DUBLIN PLANNING AND ZONING COMMISSION

CASE 2: Final Development Plan 97-081FDP - Lowell Trace PUD - Northwest Presbyterian Church, Phase 1 - 6488 Post Road

REQUEST: Review and approval of a final development plan for a 30,700-square-foot church under the Planned Unit Development provisions of Section 153.056. The site is 11.51 acres located on the north side of Post Road, the west side of Avery-Muirfield Drive, and wraps around a 2.7-acre site zoned for office at the intersection.

97-081FDP
Lowell Trace PUD
Northwest Presbyterian Church
6488 Post Road

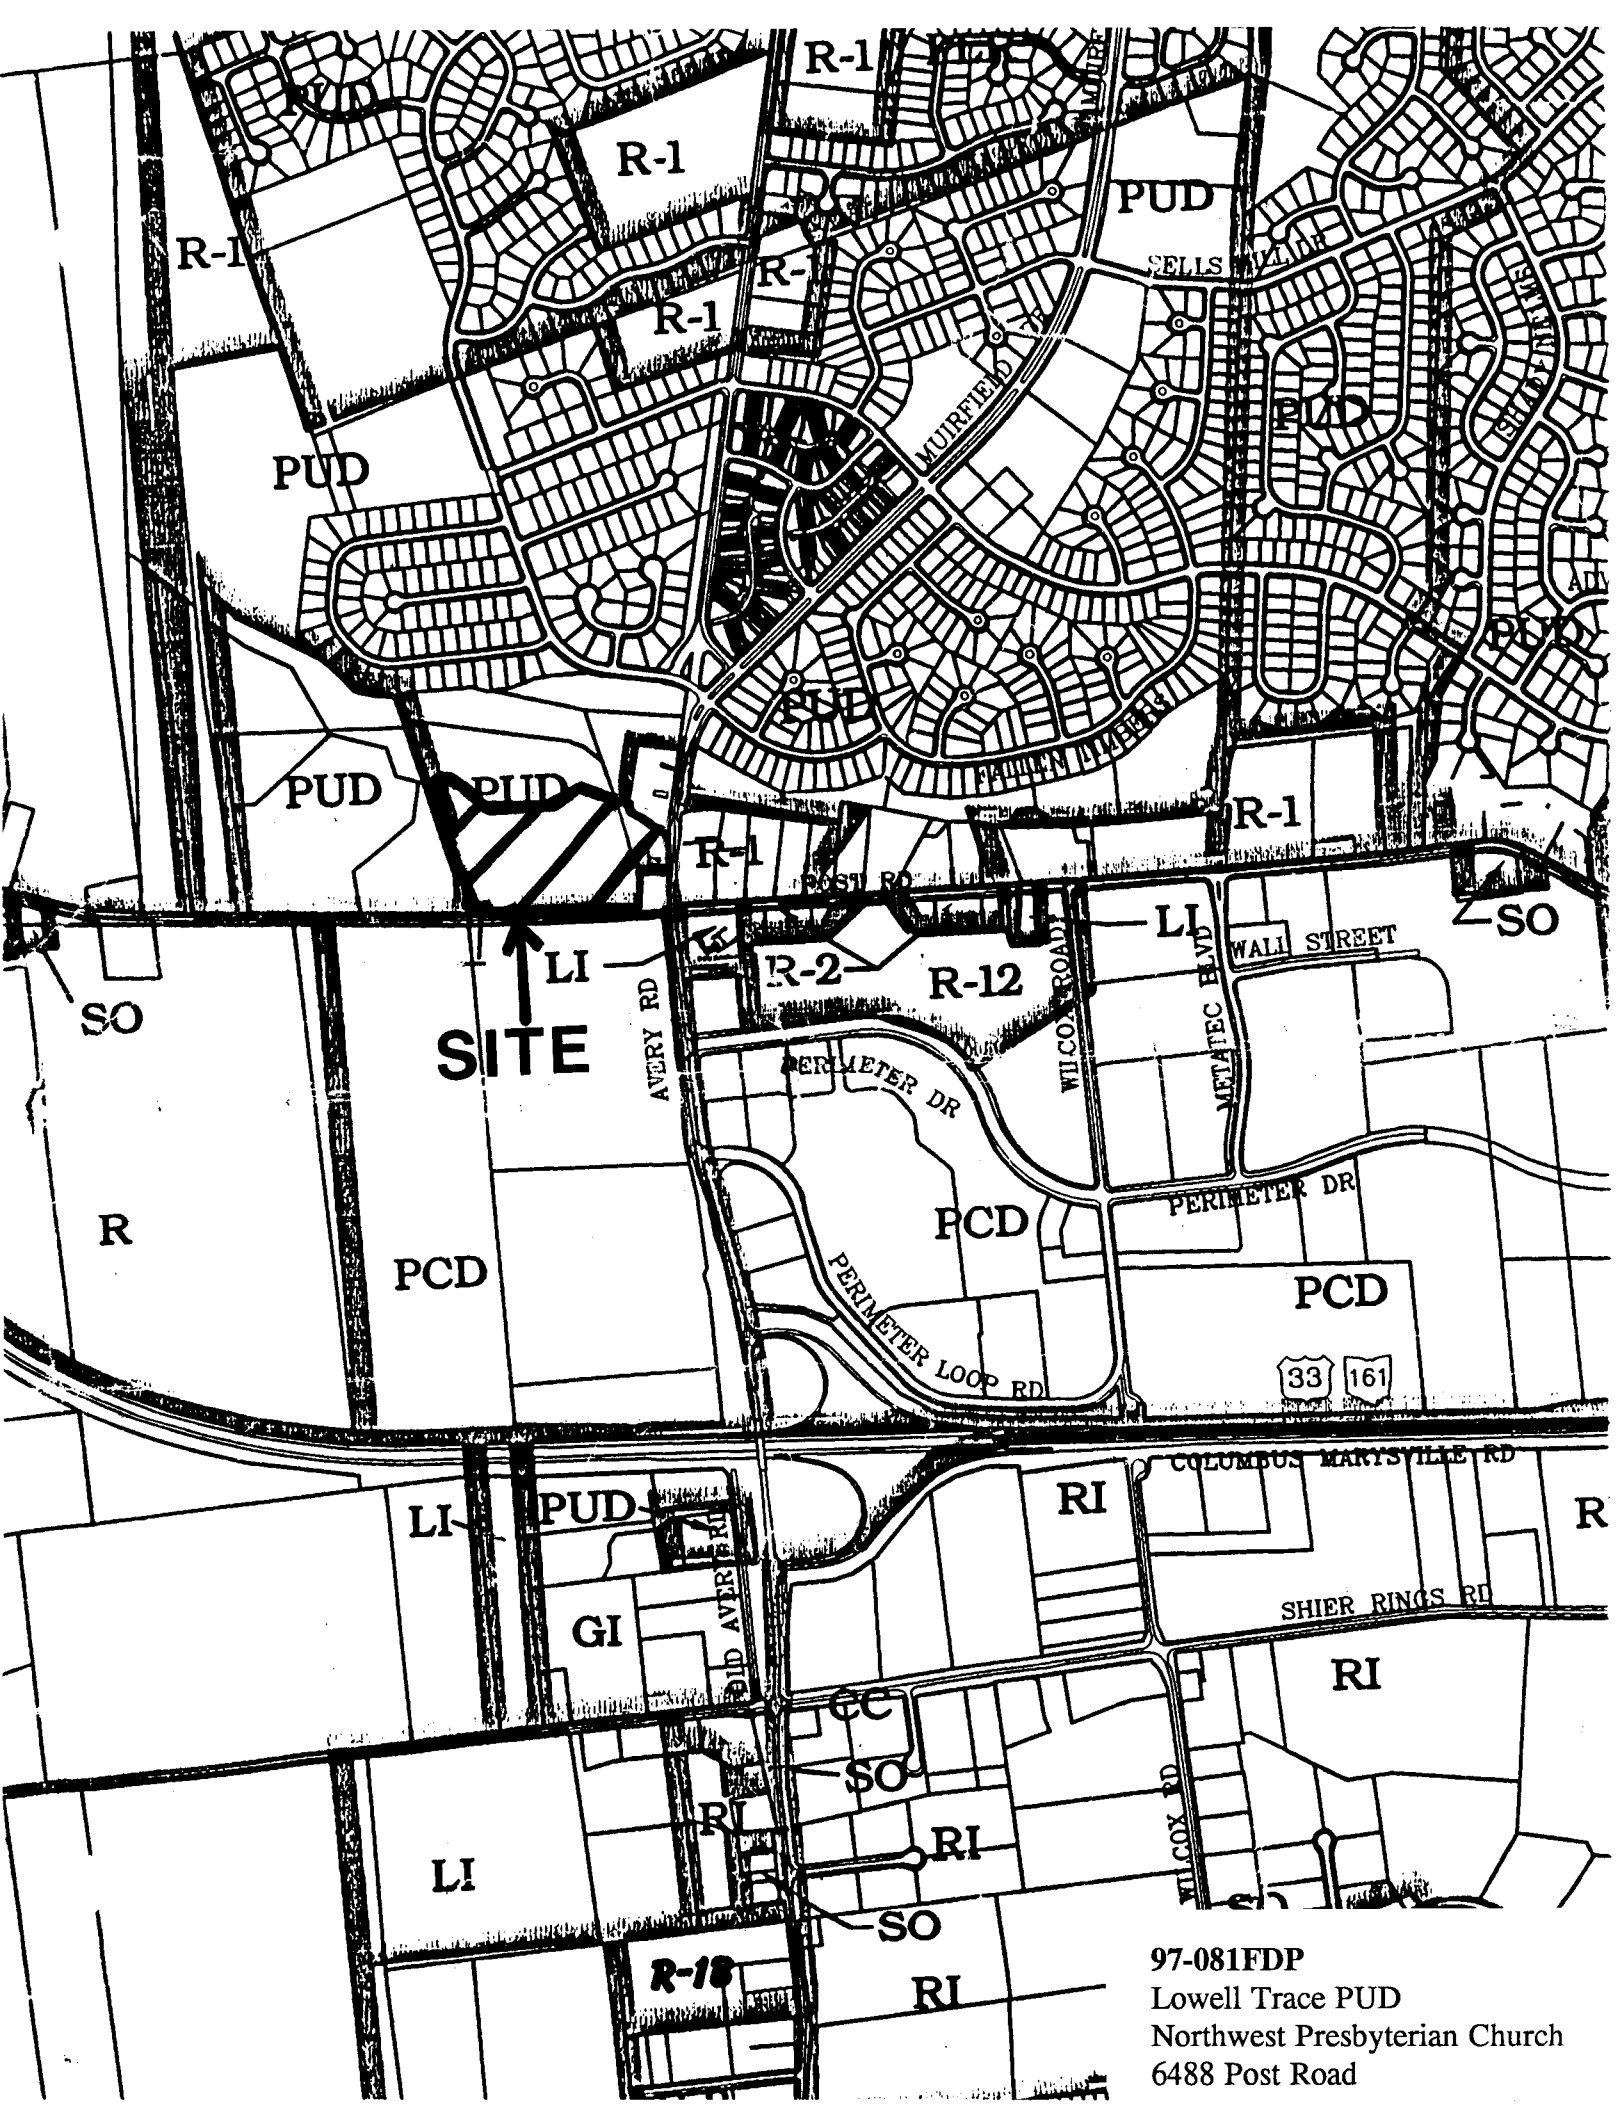
- The overall site plan shows the church backing up to the park. Parking for 543 cars is mostly located between Post Road and the church complex. The sanctuary is on the eastern end of the building and the school is on the western end. A play area is in the northwest corner of the site. Three access points are shown, two full-service curb cuts on Post Road and one right-in/right-out curb cut on Avery-Muirfield Drive. The eastern Post Road curb cut will serve as the main entrance. The office building(s) proposed at the corner will share these access points as well as some of the parking. An 8-foot bike path near the Avery-Muirfield Drive entry will provide access from this site to the park. Staff recommends that the bike path be within an easement to allow for consistent maintenance by the city.

- Minimum parking setbacks are 50 feet along all public rights-of-way and 30 feet elsewhere. The entire phase one parking area of 285 spaces is located in front of the church building along Post Road and meets the setback requirements. The text provides for the church and office sites to share parking, and during non-business hours, the parking lots may be used by the public for access to the park. A drop-off lane is proposed in front of the building which will be lengthened with future phases. On-site turning movements for bus circulation are subject to approval by the City Engineer. If buses are to be parked overnight on the site, adequate spaces and screening should be identified on the site plan. Bicycle parking is required on this site as a condition of rezoning, but is not shown on the final development plan.

- The proposed landscape plan meets the new landscape code requirements for interior landscaping and tree plantings. A complete plant list is needed showing plant names, quantities, installation sizes, etc. Plant material must be from similar climate as central Ohio. A tree preservation plan to include location of tree fencing, fertilization and pruning techniques, and utility placement must be submitted. Two groups of existing trees directly in front of the building are proposed to be saved. They are shown on the utility plan with a 6-inch water line running through them. The landscape, utility and grading plans should be revised to reflect coordination with respect to tree preservation. Mounding along Post Road is proposed consistent with the text, but mounding is not shown as required along Avery-Muirfield Drive. Landscape frontage treatment along Post Road and Avery-Muirfield Drive should consist of a minimum 3.5-foot earth mound with variable height, and one tree per 12 lineal feet of frontage. Plant material must be grouped, rather than equally spaced, along the frontages and meet the text requirements for size and type. The text also requires a landscape buffer of one tree per 15 lineal feet of property line to be installed where the subject site abuts the nursing home and the park. Street trees should be planted between the sidewalk and street where feasible. As shown, parking lot

screening does not meet code. A 3.5-foot high continuous screen plus street trees planted 40 feet apart are required.

- A dumpster is proposed in the northwest corner of the parking lot. Dumpster screening details have not been submitted, but the enclosure must be of the same architectural materials as the church building.

- A site lighting plan has not been submitted. All fixtures must be a cut-off type with a maximum height of 25 feet. Staff recommends that Dublin Lighting Guidelines be met for the entire development.

- 1) That the existing driveway for the house on the west end of the site be eliminated at the time of occupancy of this first phase;
- 2) That right-of-way along Post Road (30 feet from centerline) and Avery-Muirfield Drive (50 feet from centerline) consistent with the Thoroughfare Plan, plus an area needed at the intersection for signalization, be deeded to the city prior to issuance of building permits;
- 3) That floodway, floodway plus 20 feet, and floodplain boundaries be accurately shown on all plat, planning, building permit, and engineering documents consistent with the rezoning conditions, and that floodplain development permits be secured prior to the issuance of building permits;
- 4) That a revised landscape plan, including a complete tree preservation plan, be submitted which meets the landscape code and text requirements, subject to staff approval;

- 5) That the western Post Road driveway be widened to 36 feet;
- 6) That a 5-foot sidewalk be installed along Avery-Muirfield Drive and be shown on the site plan in a location acceptable to staff, with an easement to be provided if necessary;

- 9) That bicycle parking be shown on the site plan, subject to staff approval;
- 10) That a complete site lighting plan be submitted that meets the requirements of the text and Dublin Lighting Guidelines, subject to staff approval;
